Access Compliance Report

Public Rights-of-Way

(Curb Ramps)

Intersection ID: 10025384	Main Street: E_9TH_ST	Cross Street: N/A	Location: NE
ADA ID: 2F822CA6366F	Ramp Type: BlendTrans1	Initial Pass/Fail: Fail	Overall Compliance: No
Severity Score: 8.75			
Codes/Mitigation Info/Possible Solution		Field Measurements/Component Compliance

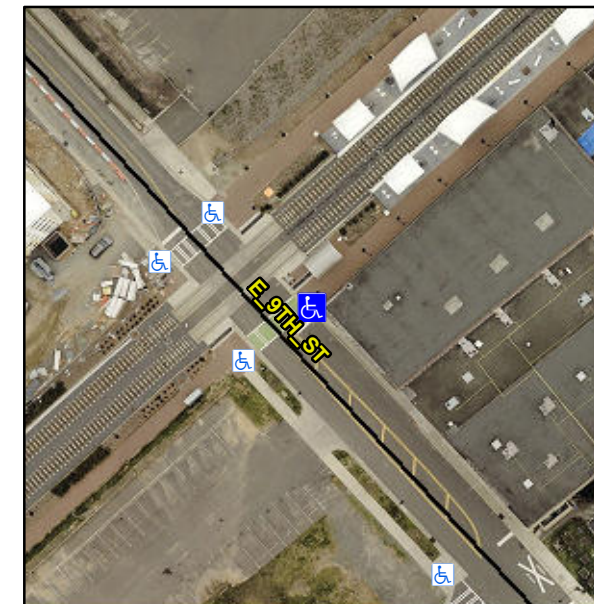
PROW/ADA:

Not Found, R304.5.1

Remove & Replace Curb Ramp With Two New Directional Ramps or Equivalent.
